NOTICE PLAN COMMISSION March 17, 2015

TO: Plan Commission
FROM: Tom Hovel, Zoning Administrator/City Planner
Susan Badtke, Community Planner
DATE: March 12, 2015
SUBJECT: March 17, 2015 Plan Commission Items

**Amendment to
Comprehensive Development Plan
Previously Approved
Under Resolution R-12-14
Quarry Vista
Fitchburg, Wisconsin**

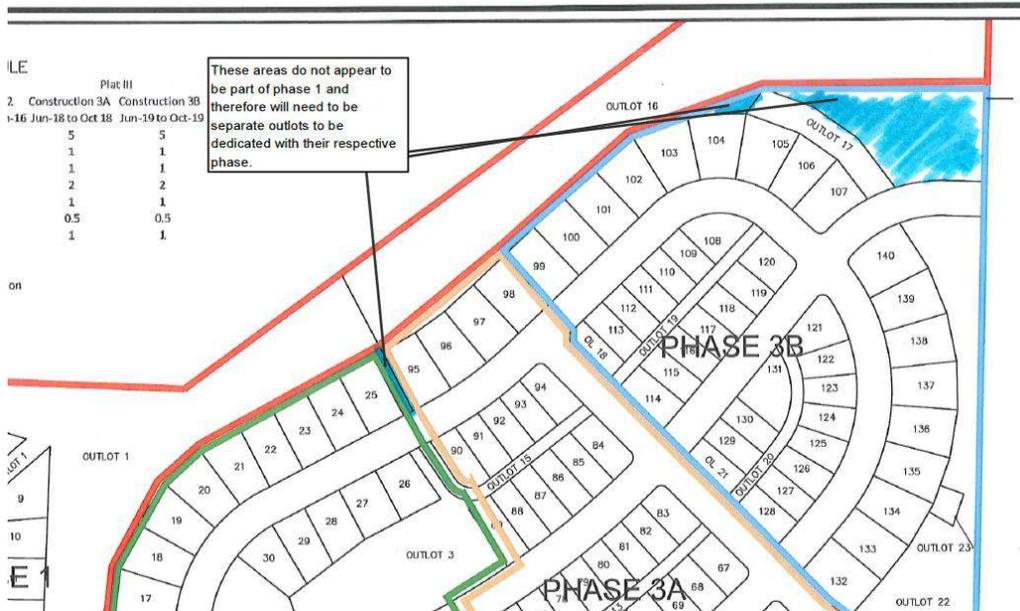
- 5.) In comparing the CDP phasing plan to the preliminary plat, it appears that there are portions of outlots 1 & 16 that will not be dedicated to the City during phase 1. If correct, these will need to be separate outlots to match the phasing. The areas are identified in the image below.
